**NSLPP MEETING HELD ON 05/04/2023****Attachments:**

ADDRESS/WARD: 37 Bay View Street, McMahons Point**APPLICATION No:** 418/21**PROPOSAL:** Erection of dwelling house and associated works**PLANS REF:**

OWNER: P Dugal**APPLICANT:** P Dugal, C/- Architecture Saville Isaacs**AUTHOR:** Jim Davies, Executive Planner**DATE OF REPORT:** 23 March 2023**DATE LODGED:** 3 December 2022**RECOMMENDATION:** Deferred Commencement

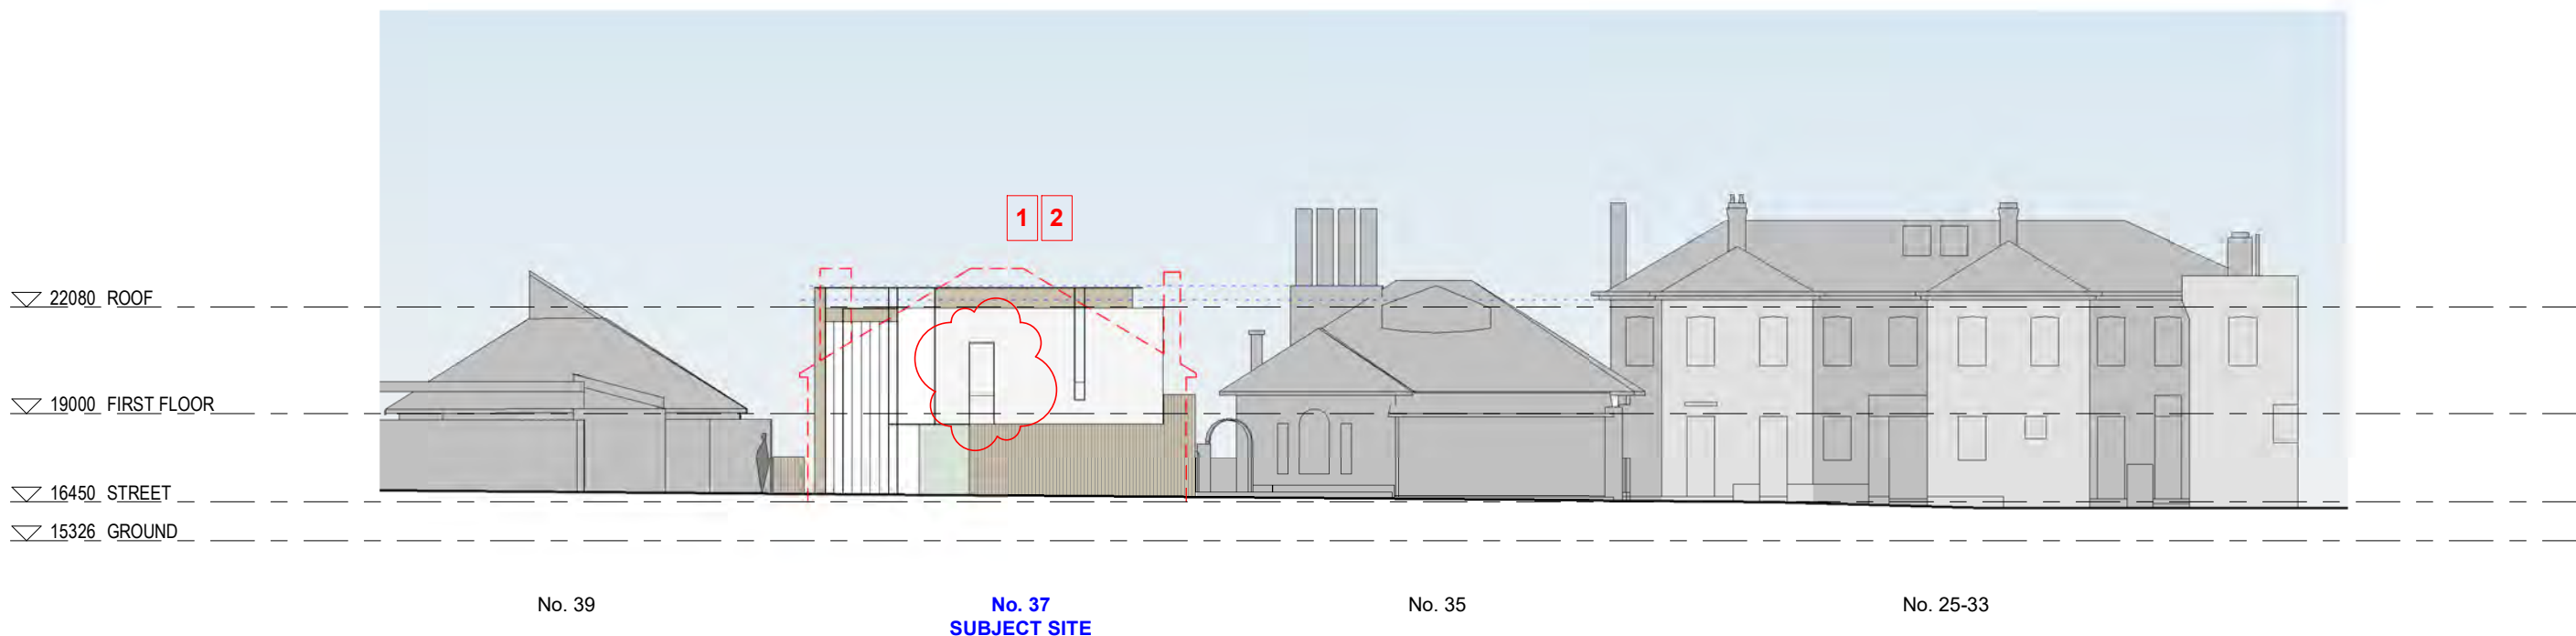
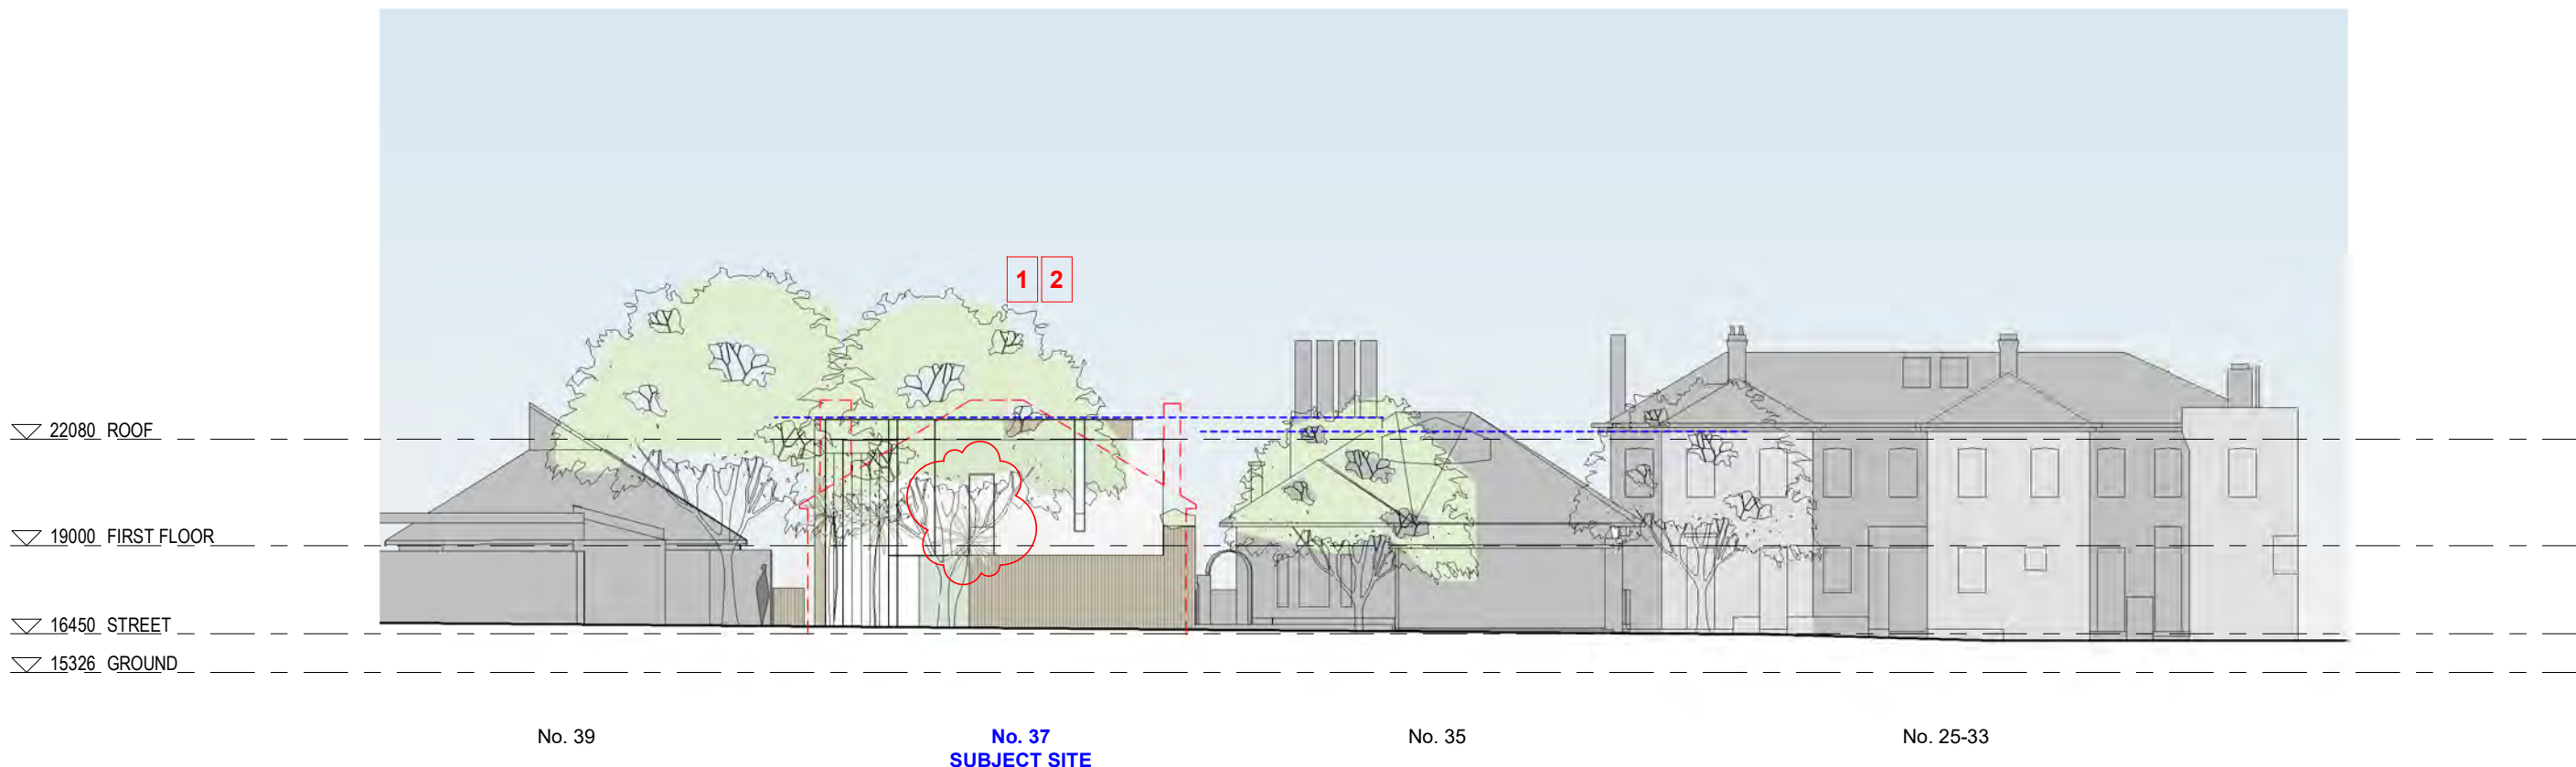
- 1 MINOR ADJUSTMENT TO STREET FACADE. WINDOW ADDED AS PER COUNCIL'S ADVICE
- 2 MINOR CHANGE TO FINISH AS PER COUNCIL'S ADVICE

Date	Rev	Issue	CLIENT	PROJECT	TITLE
2022.08.17	B	DA - Adjusted Graphics	T + P DUGAL	37 BAY VIEW STREET LAVENDER BAY, NSW	Elevation West (Street)
2022.11.30	C	DA - Additional Information			JOB No. 2033
2023.03.14	D	DA - Additional Information			DRAWING No. DA201
					REV. D

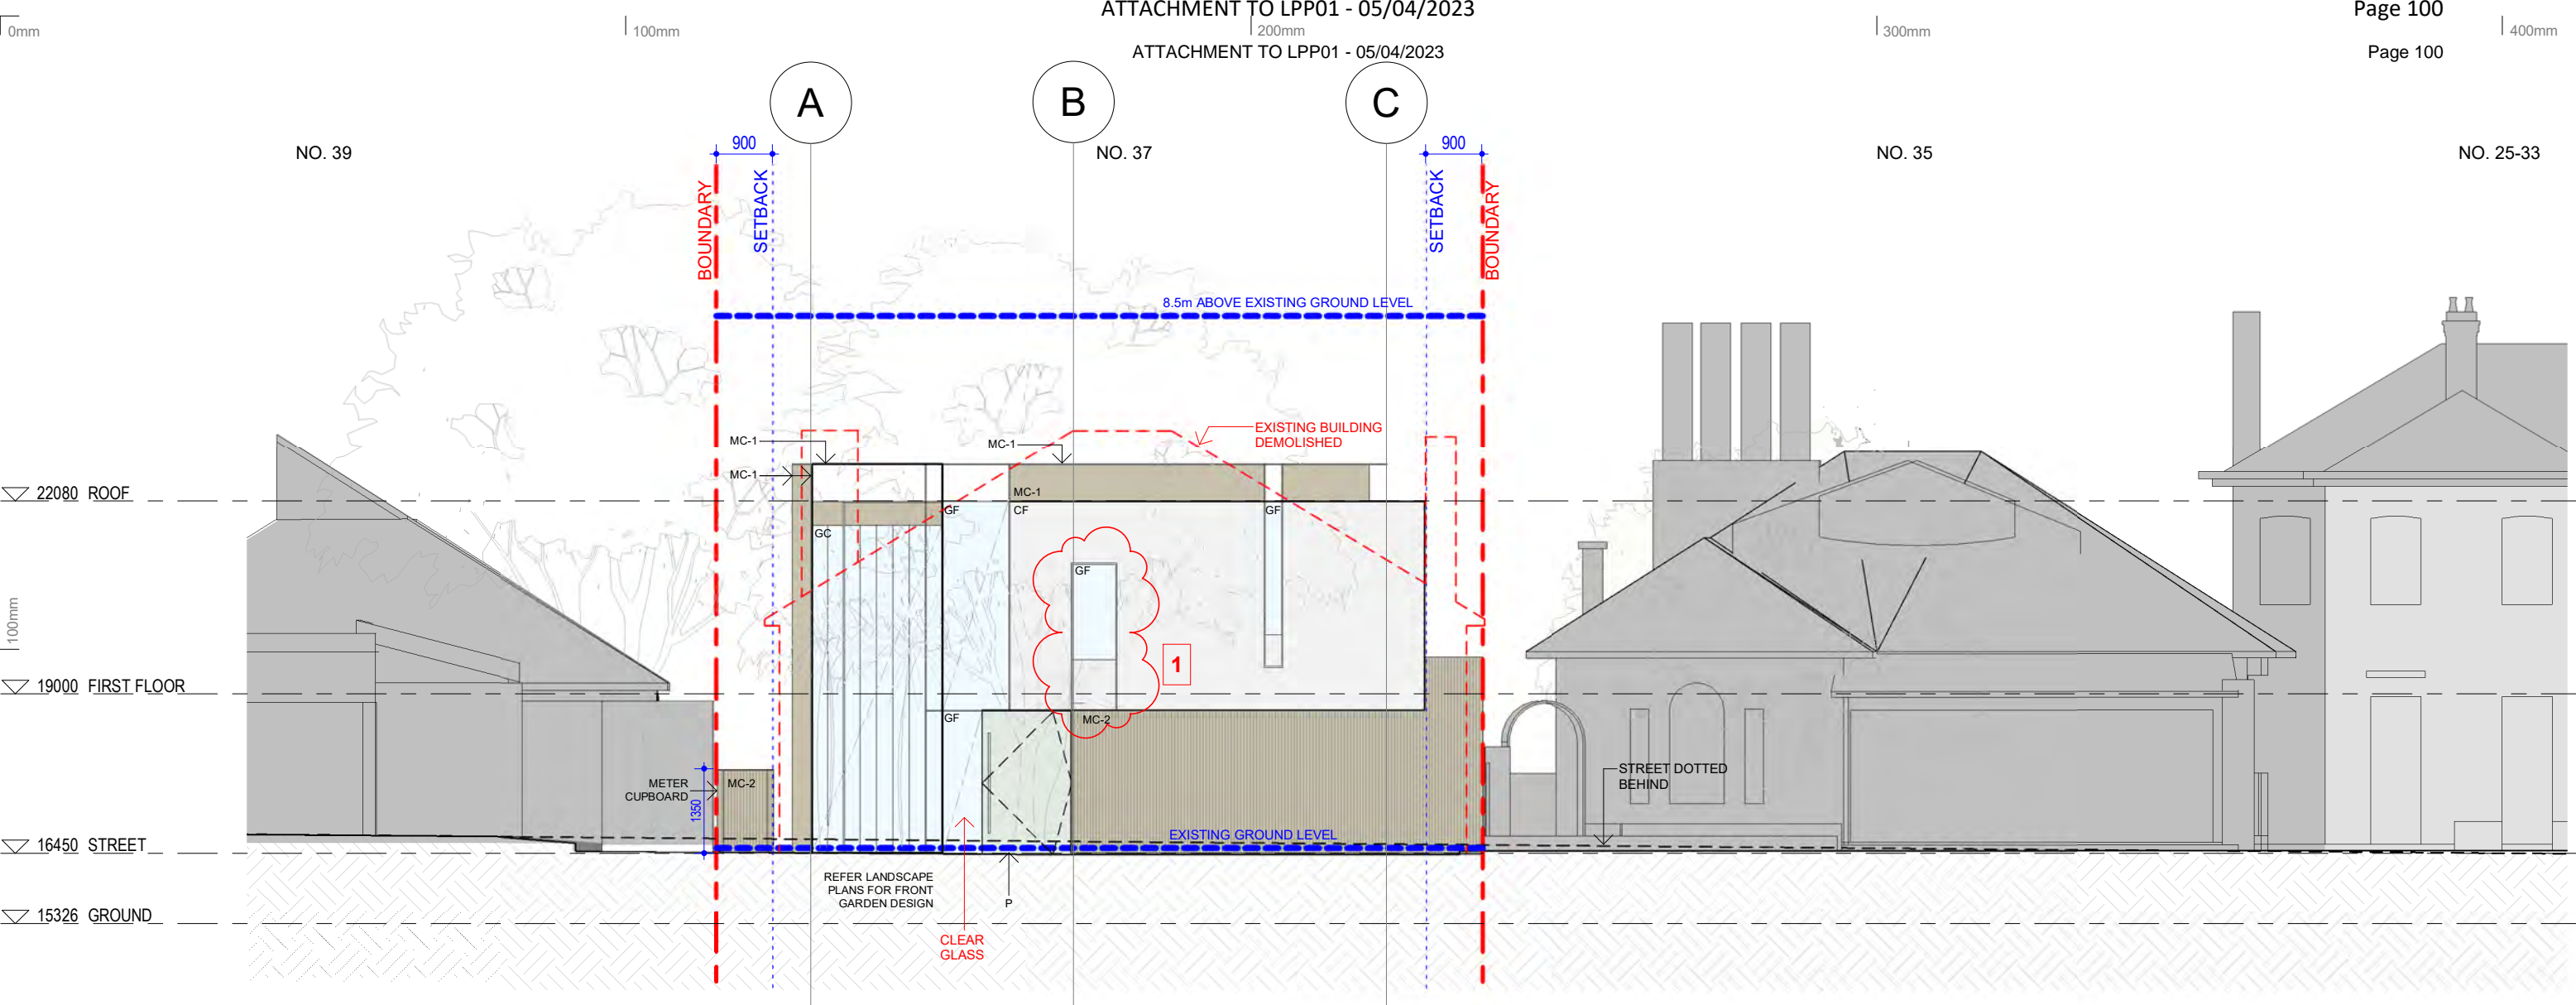
- 1** MINOR ADJUSTMENT TO STREET FACADE. WINDOW ADDED AS PER COUNCIL'S ADVICE
- 2** MINOR CHANGE TO FINISH AS PER COUNCIL'S ADVICE

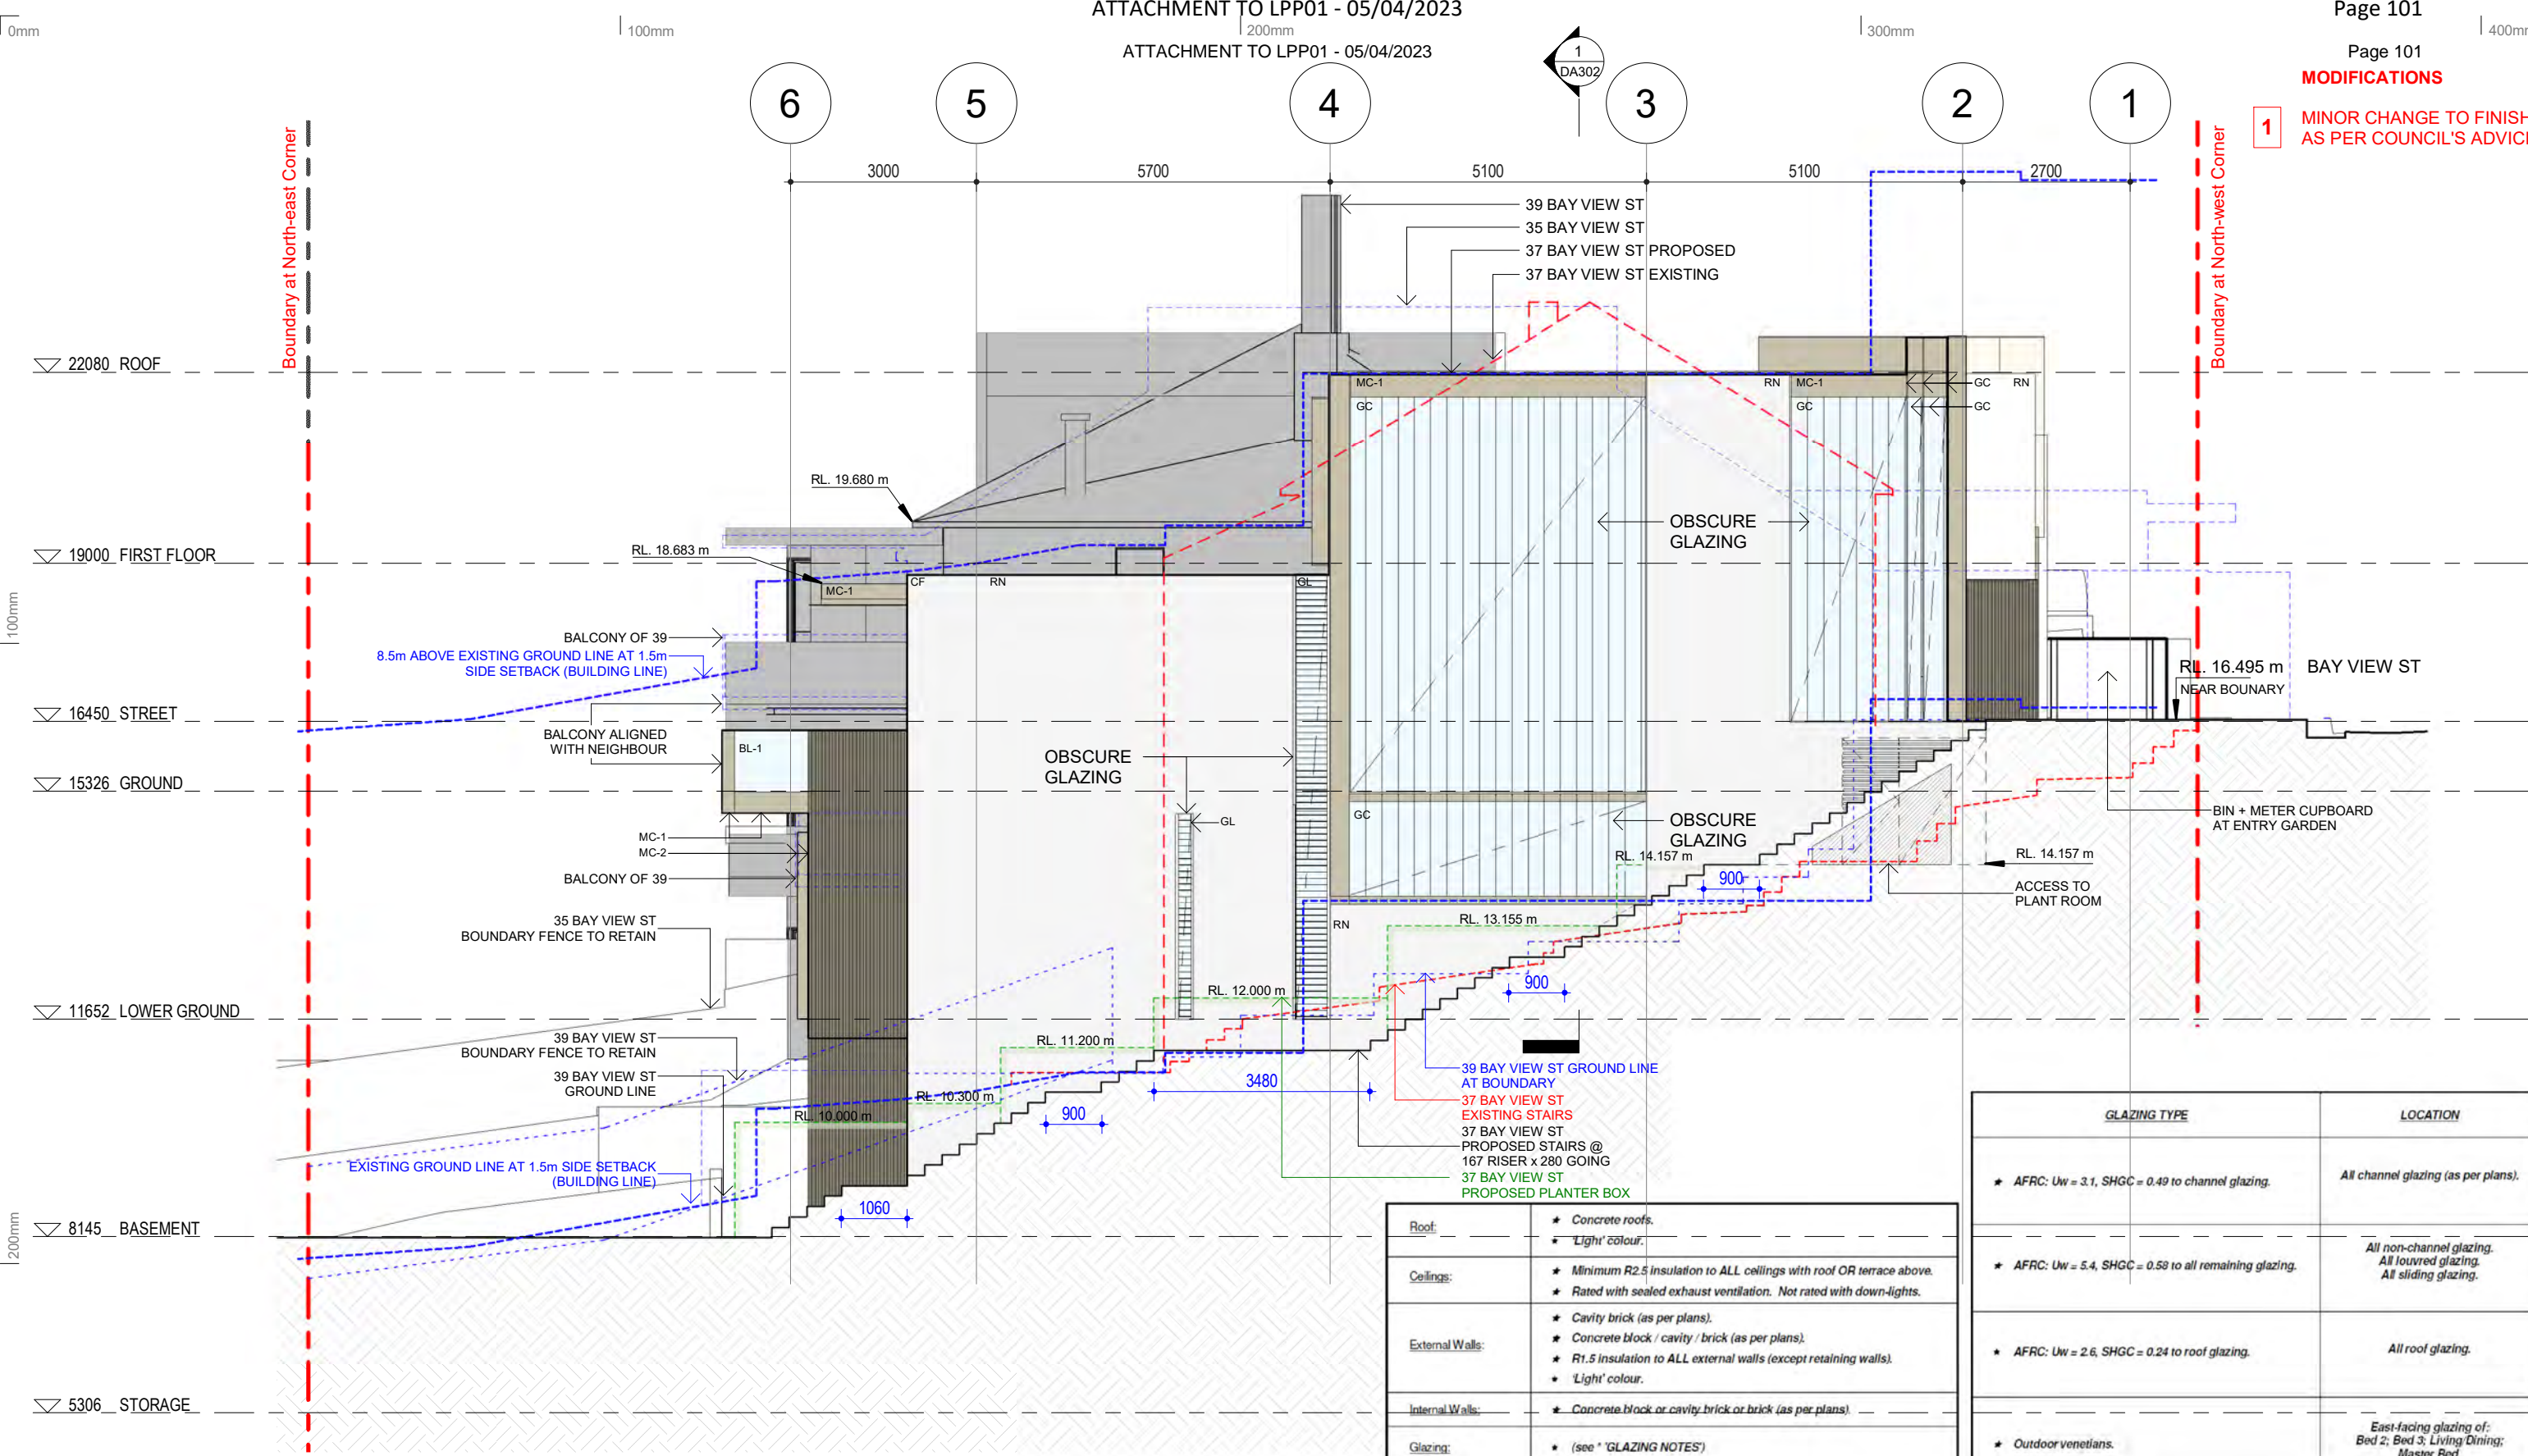
1 MINOR CHANGE TO FINISH AS PER COUNCIL'S ADVICE
